**Stubbo Solar Farm (SSD-10452)**  
**Confirmation of connection point (Option A) and subdivision area**

This letter provides confirmation of Option A as the connection point and confirmation that the subdivision for the switchyard is generally in accordance with the Environmental Impact Statement (EIS) and the Development Consent for the Stubbo Solar Farm project.

**Attachment B – STSF-P019 Stubbo Solar Subdivision Area – 11 July 2023**

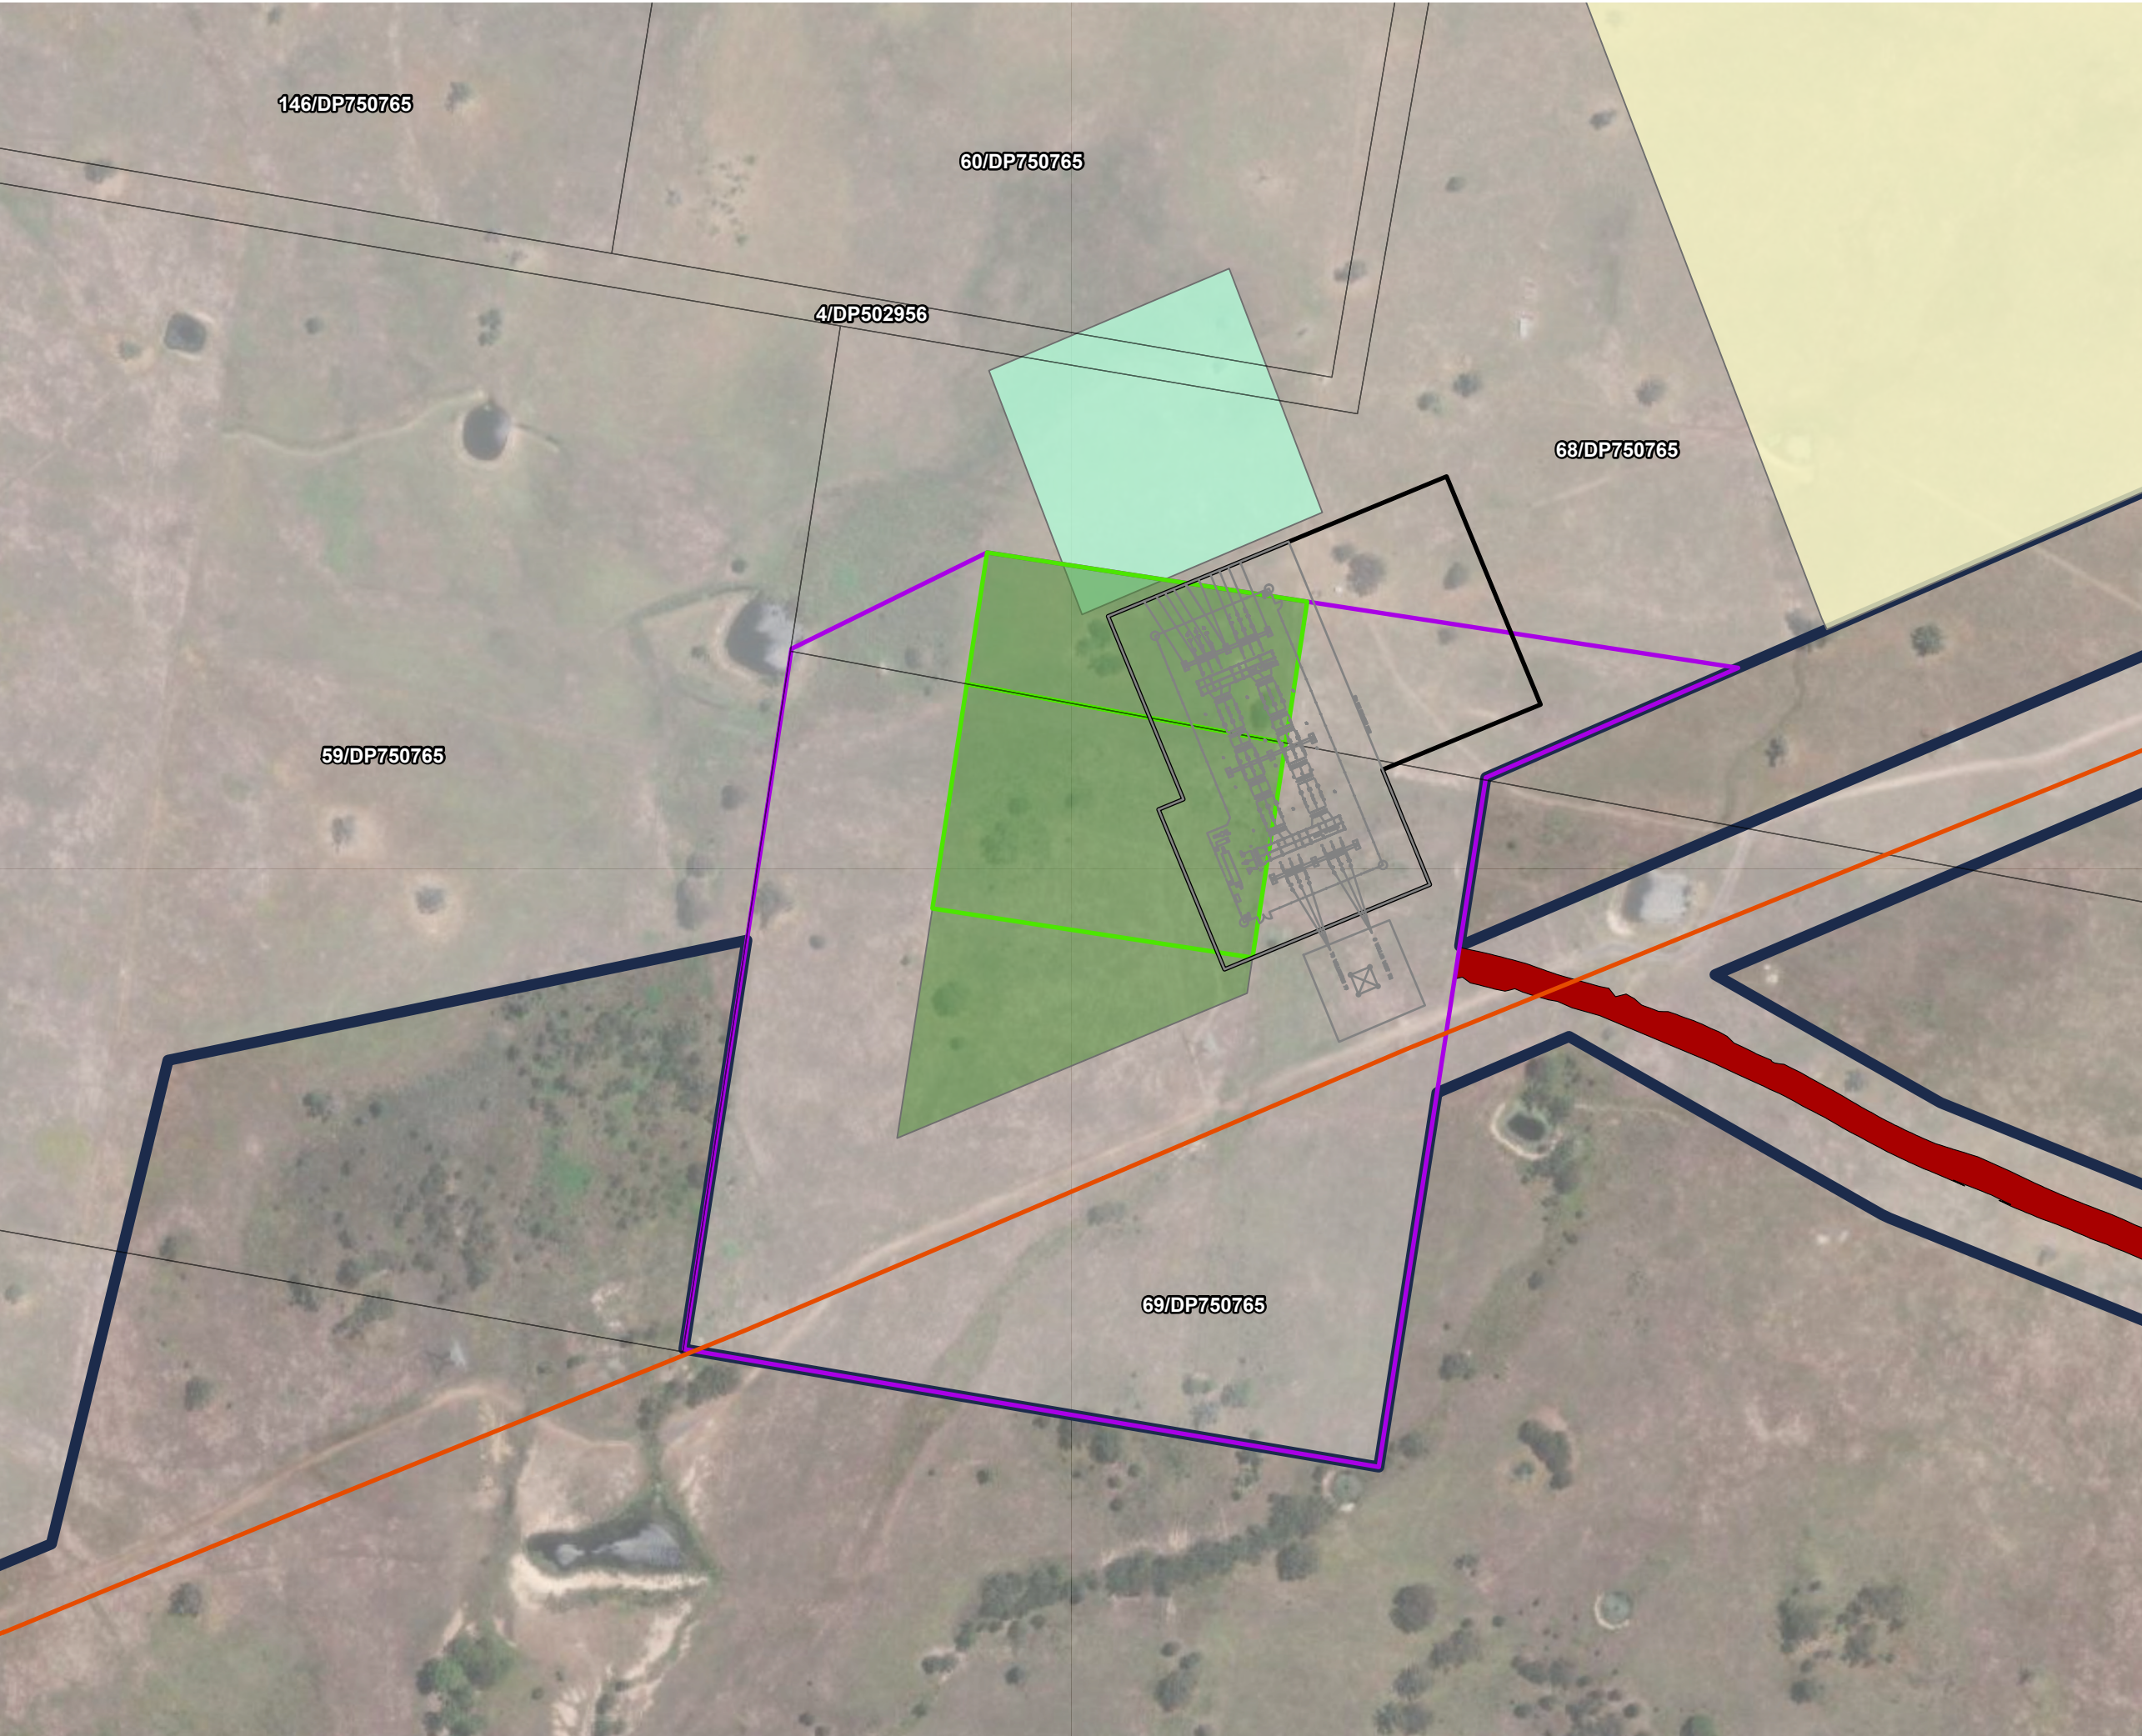
A comparison of the Subdivision Plan in the Development Consent and the Proposed Subdivision Plan respectively is shown in **Attachment B**. The key features are outlined in the following table:

| Feature                                 | Subdivision Plan in the Development Consent                                 | Subdivision Plan in the Final Layout Plan                       | Comment                                              |
|-----------------------------------------|-----------------------------------------------------------------------------|-----------------------------------------------------------------|------------------------------------------------------|
| Orientation                             | Approx 45° to Transmission Line 79 as per Appendix 4 of Development Consent | Rotated approx. 45° to be perpendicular to Transmission Line 79 | Requested by Transgrid. (Refer <b>Attachment C</b> ) |
| Area                                    | 3.7 ha (indicative)                                                         | 3.681 ha                                                        | Smaller area                                         |

There has been significant design development for the switchyard position, from the initial planning to the final location of the switchyard. The current orientation of the switchyard is optimised to suit access to the transmission line (TL79) and the Solar Farm substation.

In addition, the switchyard has been repositioned from the indicative position shown in the EIS and Development Consent, to the final layout position to achieve a perpendicular line cut-in from TL79 to the new switchyard. This approach was adopted to provide an effective and efficient access to the transmission line from the switchyard.

As noted by Transgrid (**Attachment C**), when a line is cut-in at a non-perpendicular orientation, it leads to additional complexities and electrical safety aspects. These relate to the corresponding uneven mechanical loads on the transmission line fixture, structure and footings, plus additional complexities relating to electrical properties for ground to earth, and phase to phase, electrical clearances to account for conductor movement. These complexities can be mitigated and controlled more efficiently by the Stubbo Solar switchyard being oriented perpendicularly to the transmission line TL79 instead of at a 45-degree cut in angle as indicatively shown in the EIS and Development Consent.

Additionally, a perpendicular entry is shorter than an angled entry to the transmission line and will require a smaller area to achieve the cut in.
